# **ADDENDUM NO. 1**

## **Middle Georgia Regional Airport (MCN)**

**PA PN 20202946.0003**

Issued: June 16, 2023

SHEET: **EA-001**

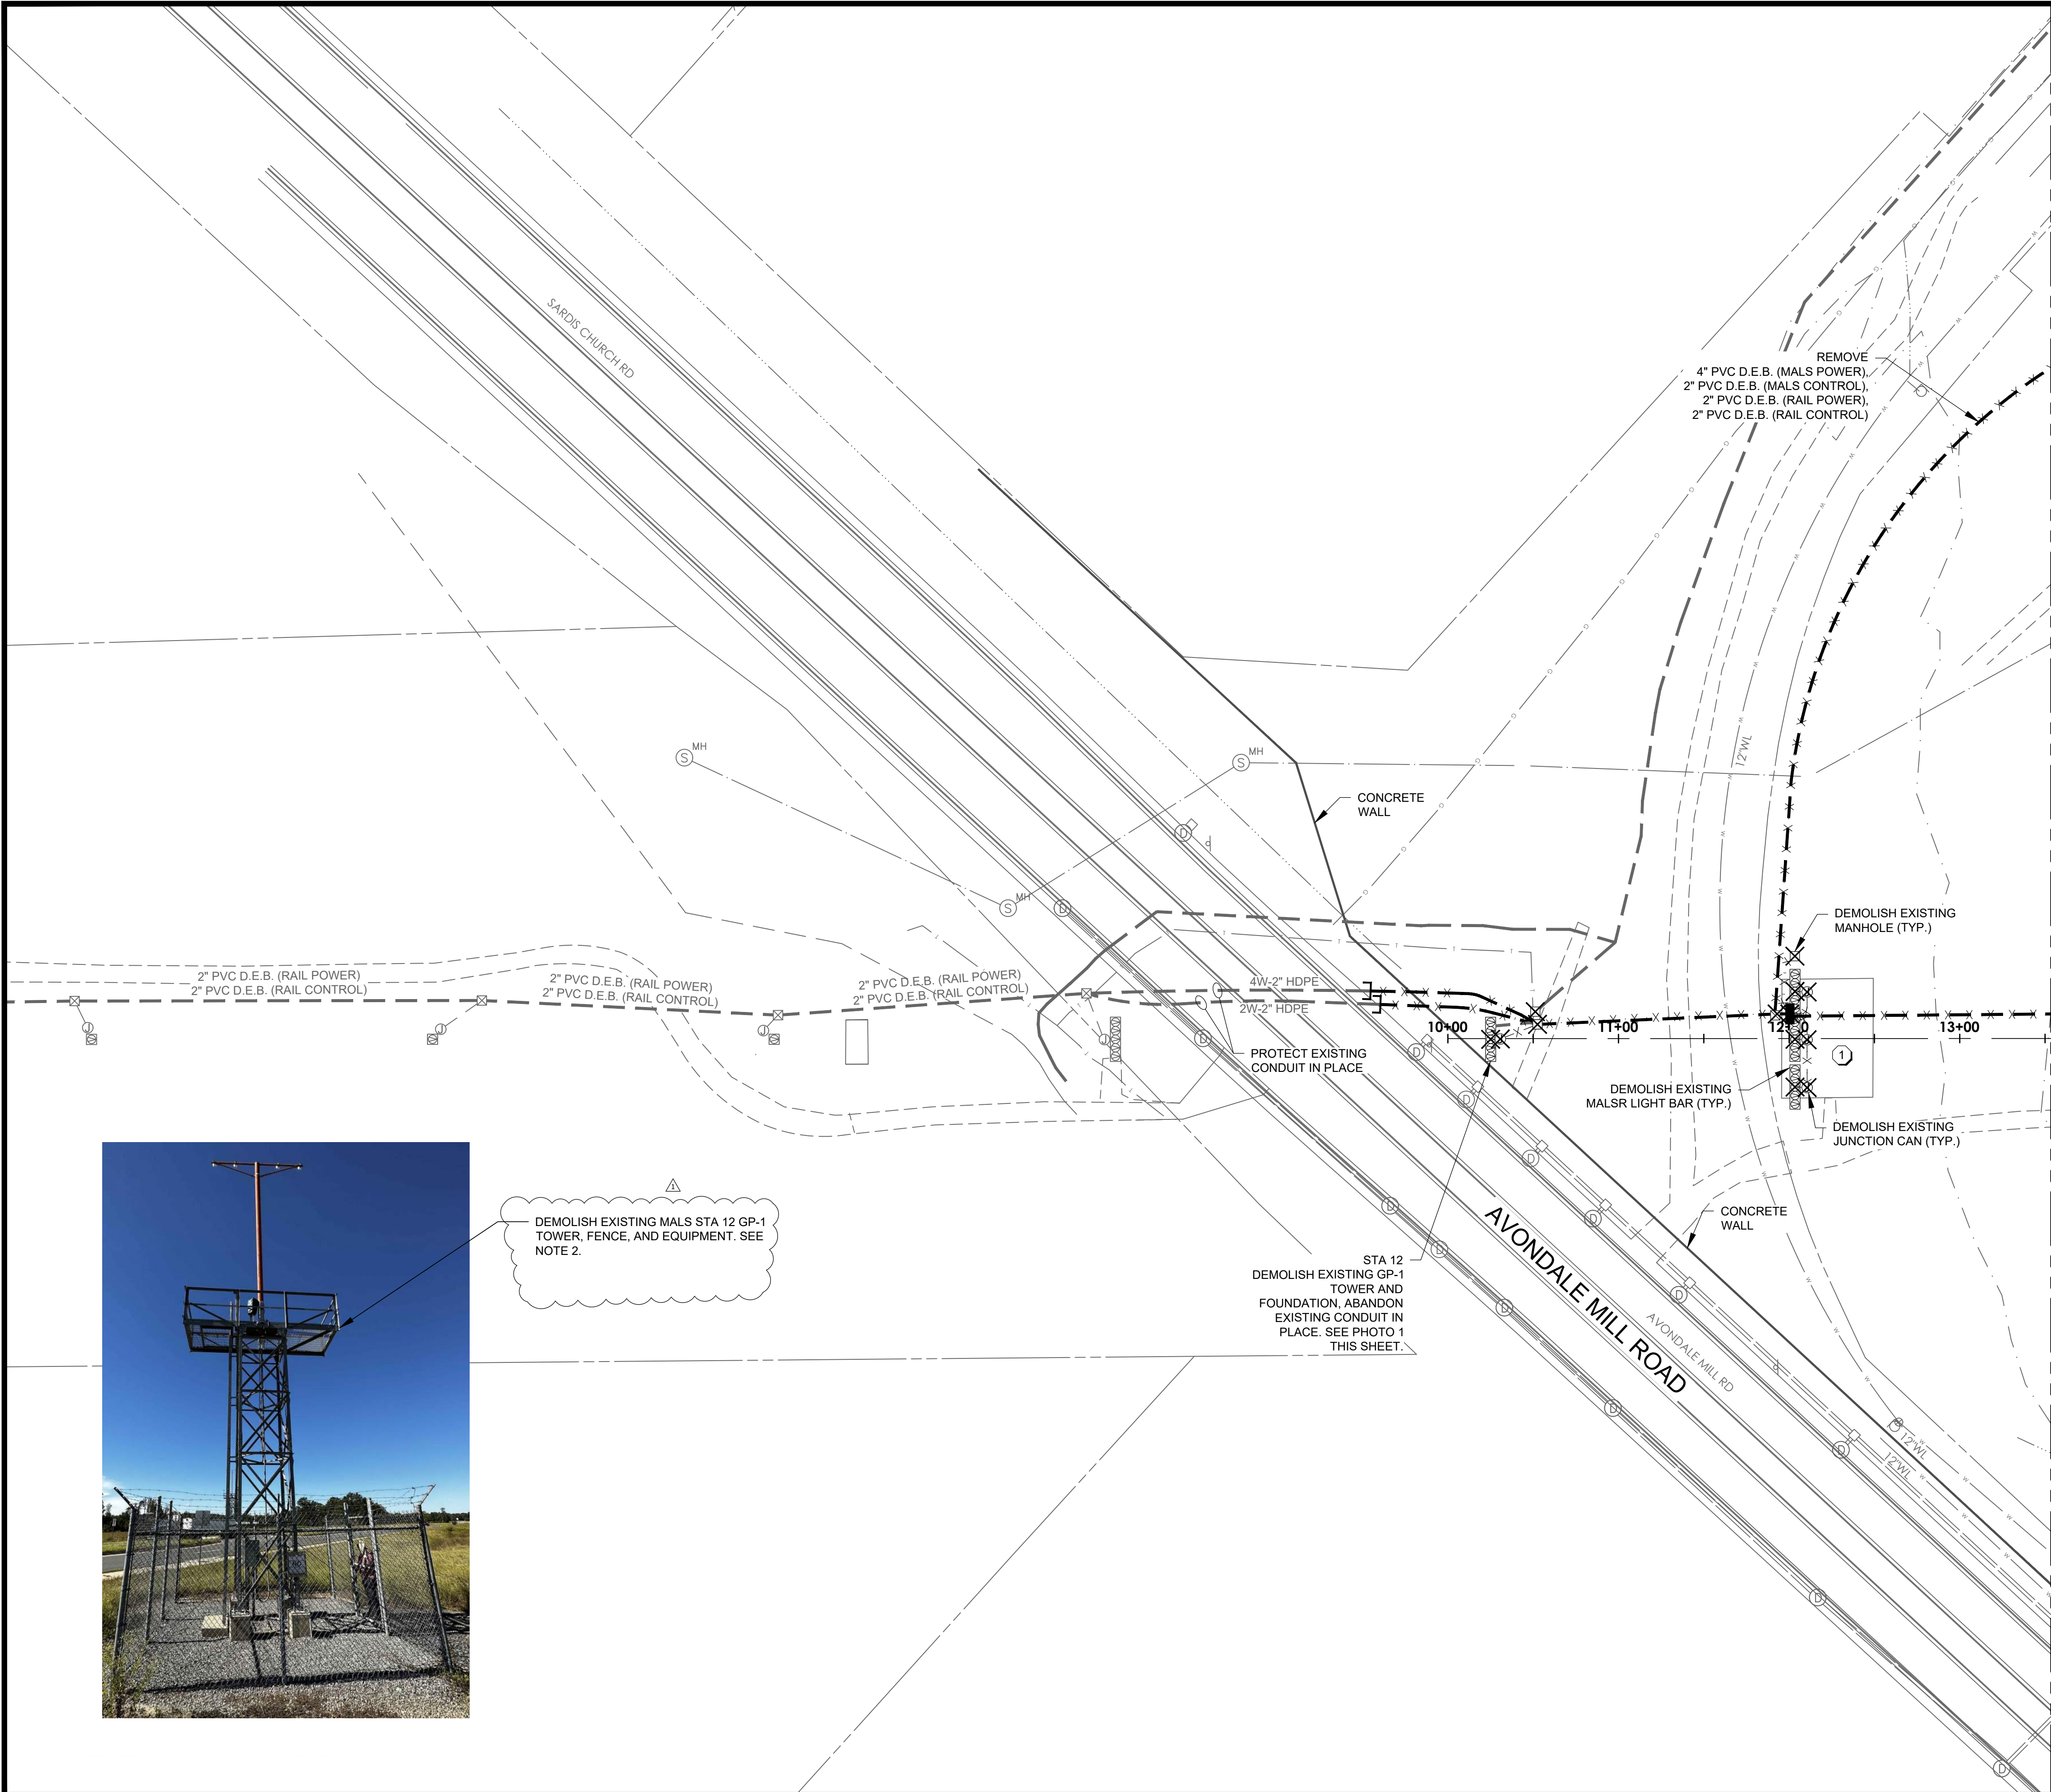
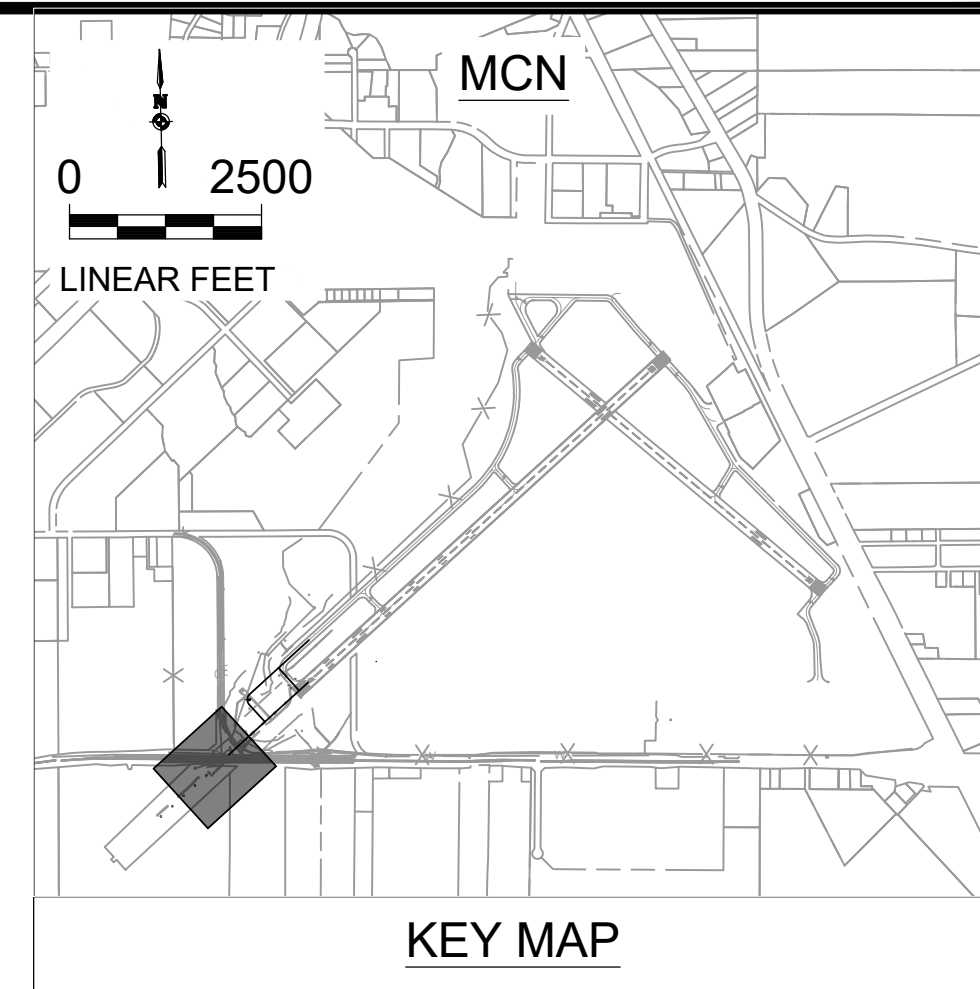
**REPLACE** electrical sheets with revised, attached sheets, EA-001, EA-101 through 103, EA-203, EA-204, and EA-301 through EA-304.
